# ARAPAHO ROAD - PHASE III

FROM SURVEYOR BOULEVARD TO ADDISON ROAD

PROJECT RECORD COPY I

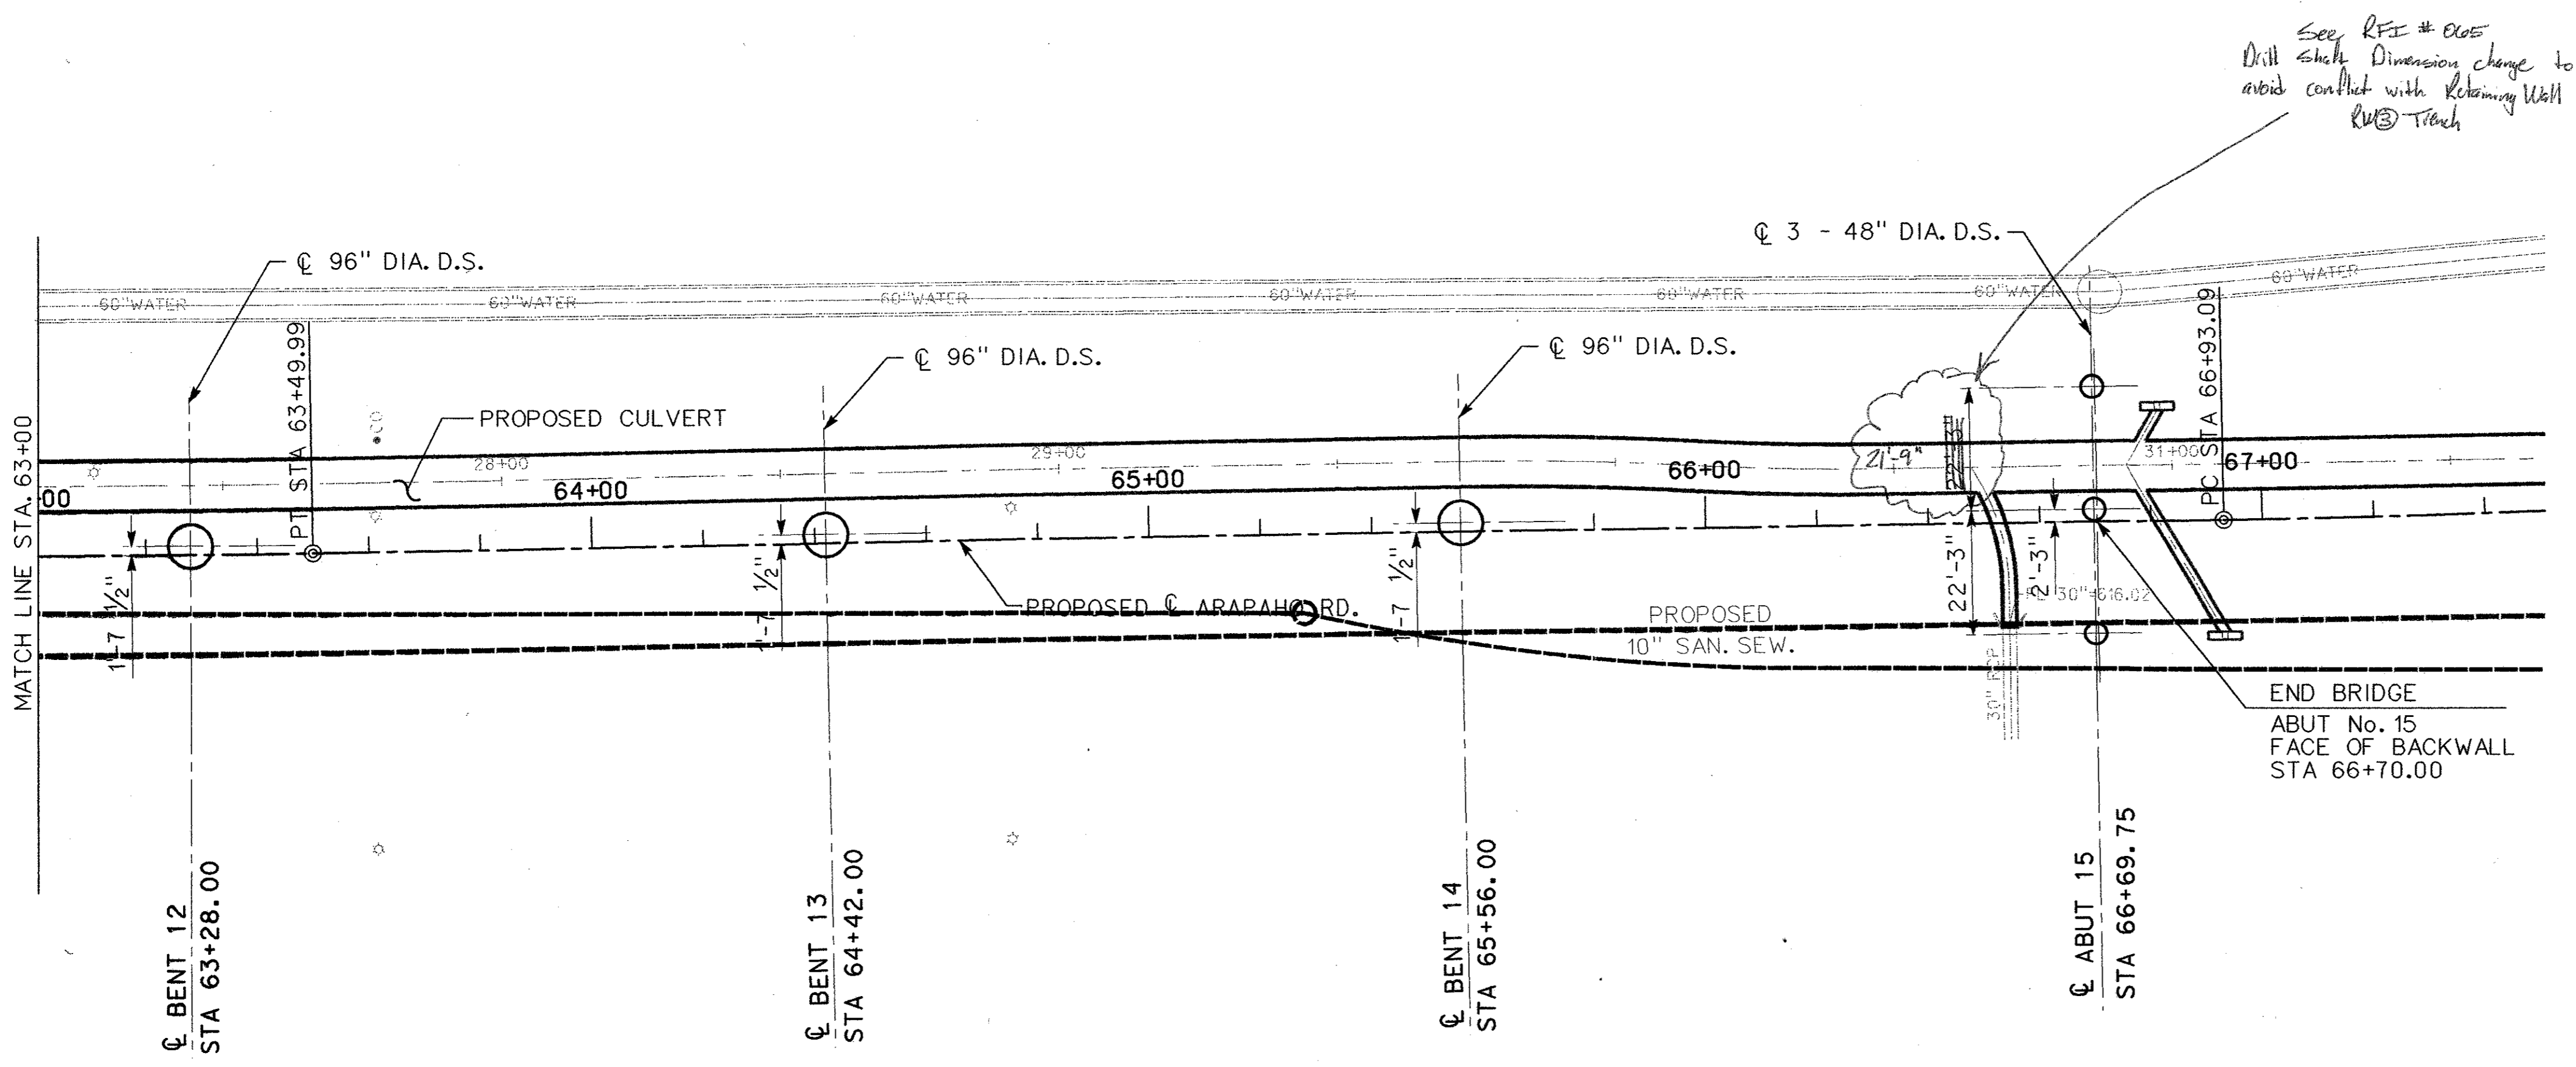
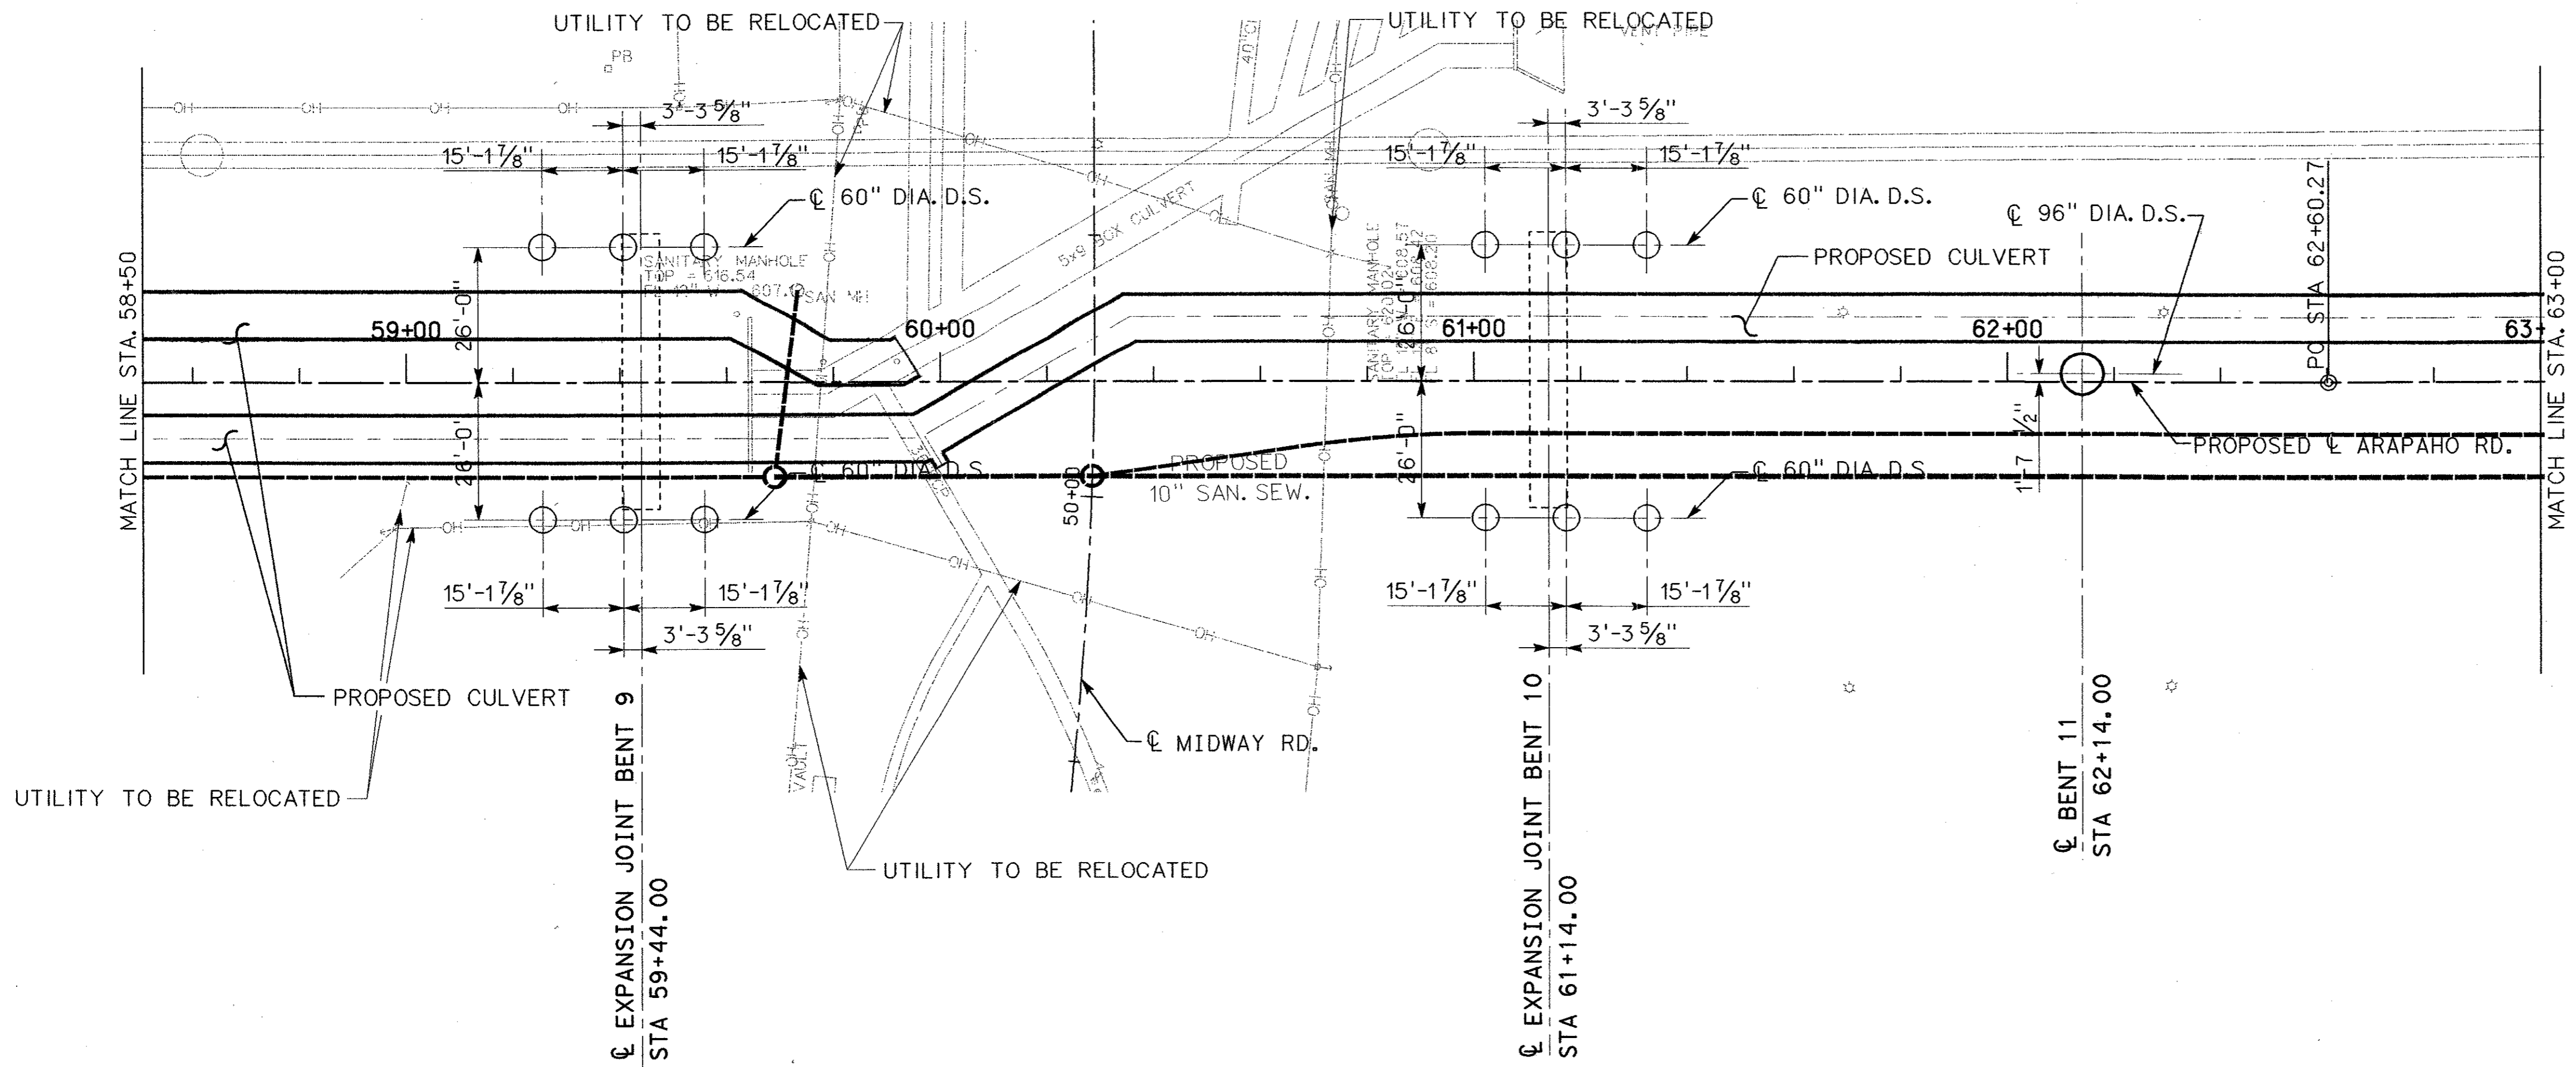
See RFI # 005  
 Drill shaft dimension change to  
 avoid conflict with Retaining Wall  
 RW 3 Trench

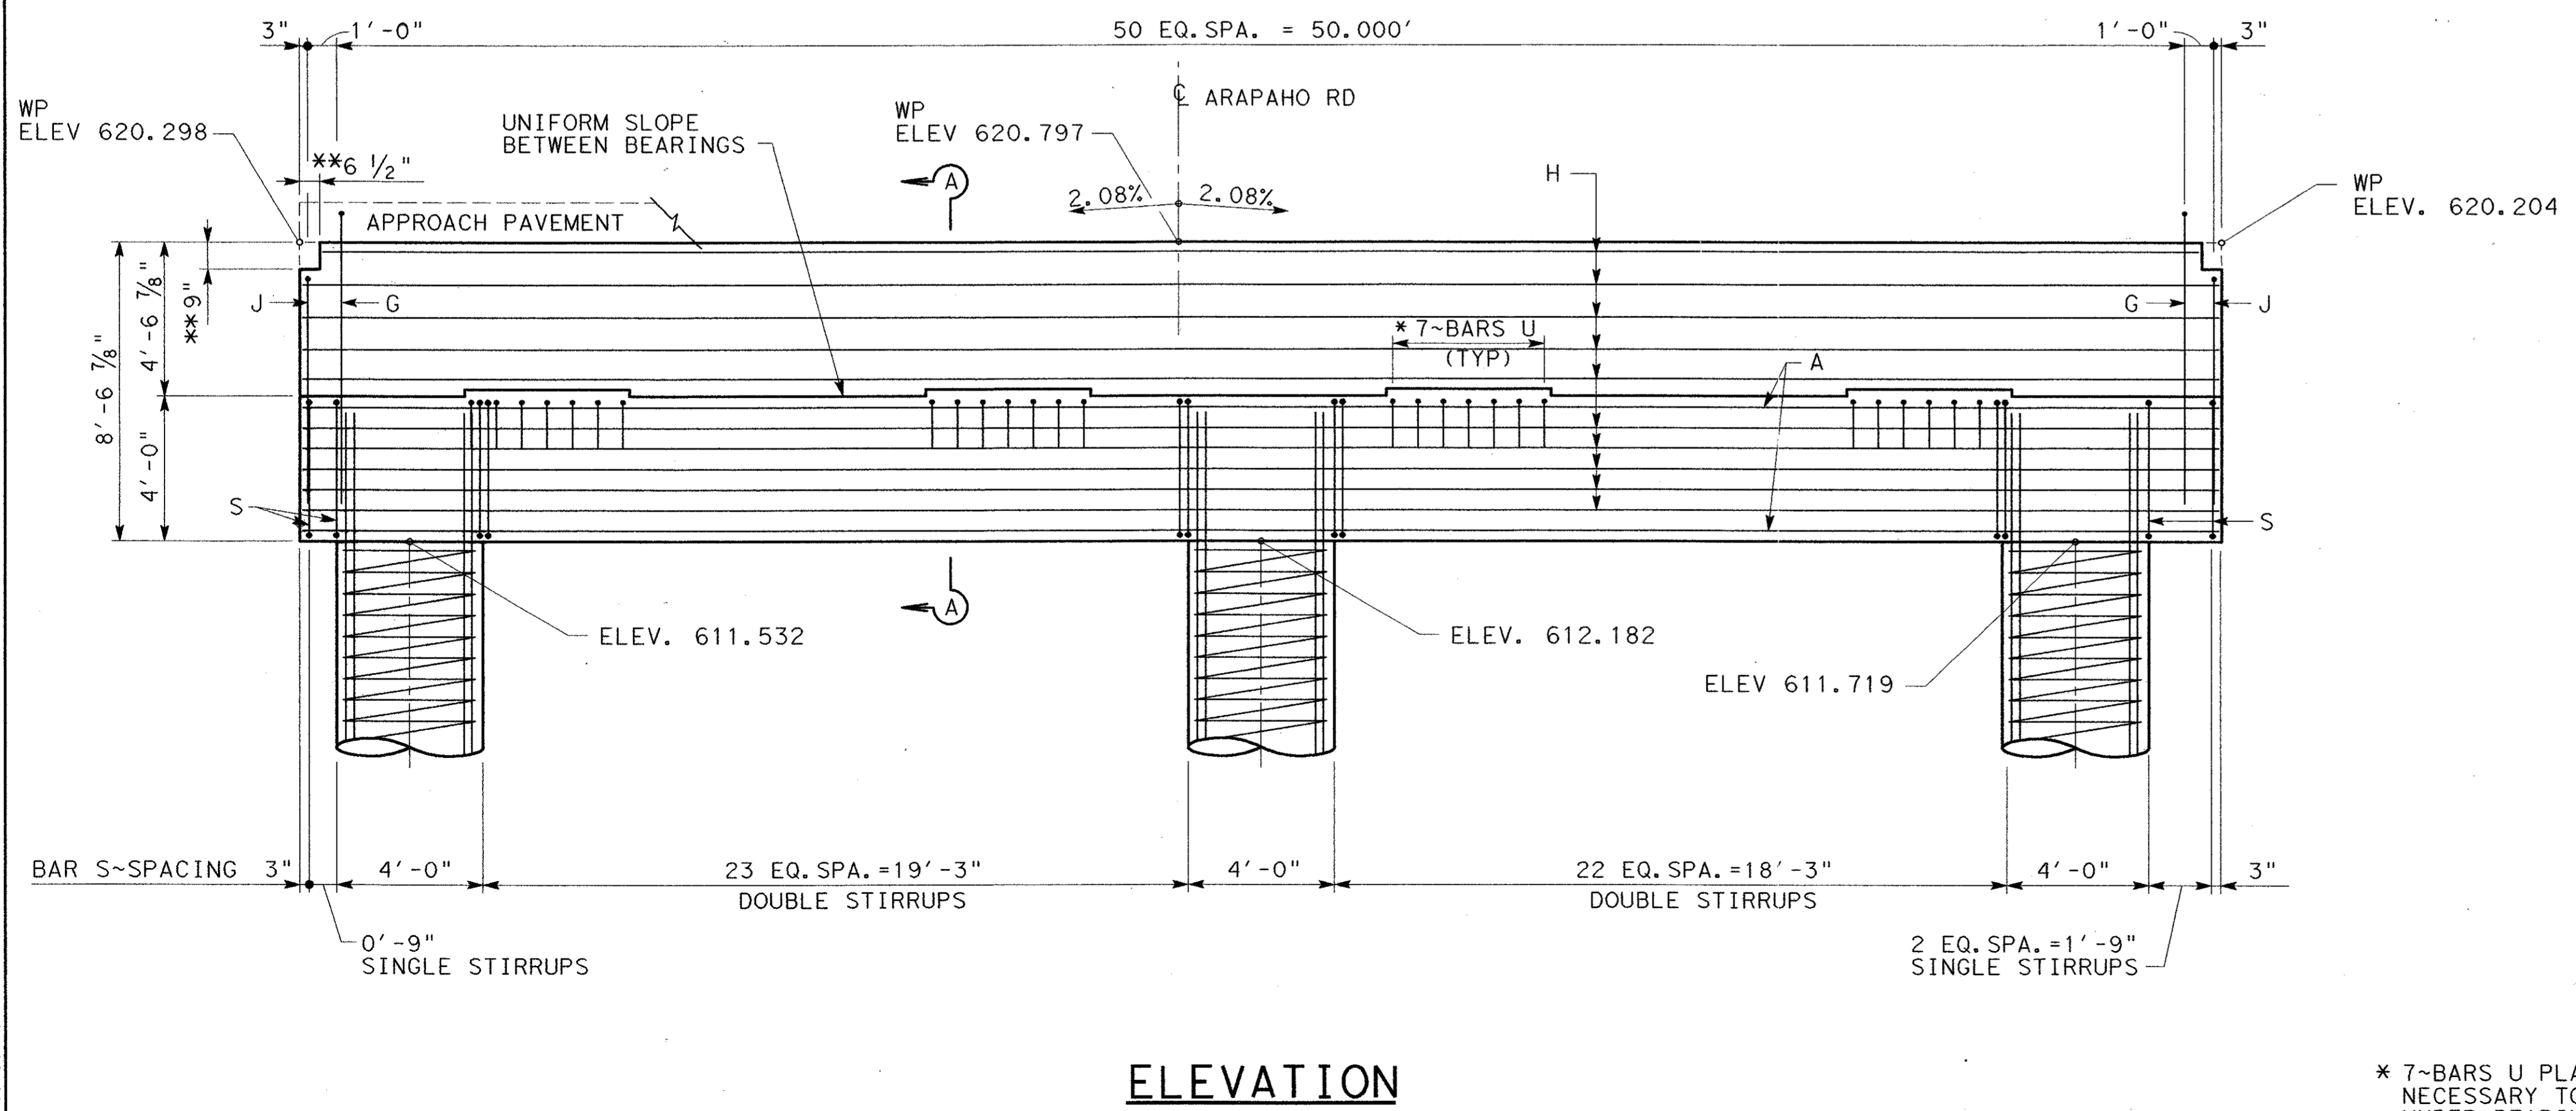
See RFI#005  
Dimension changes to Abut#1 Cap to avoid conflict with Retaining Walls RW(1) and RW(2)
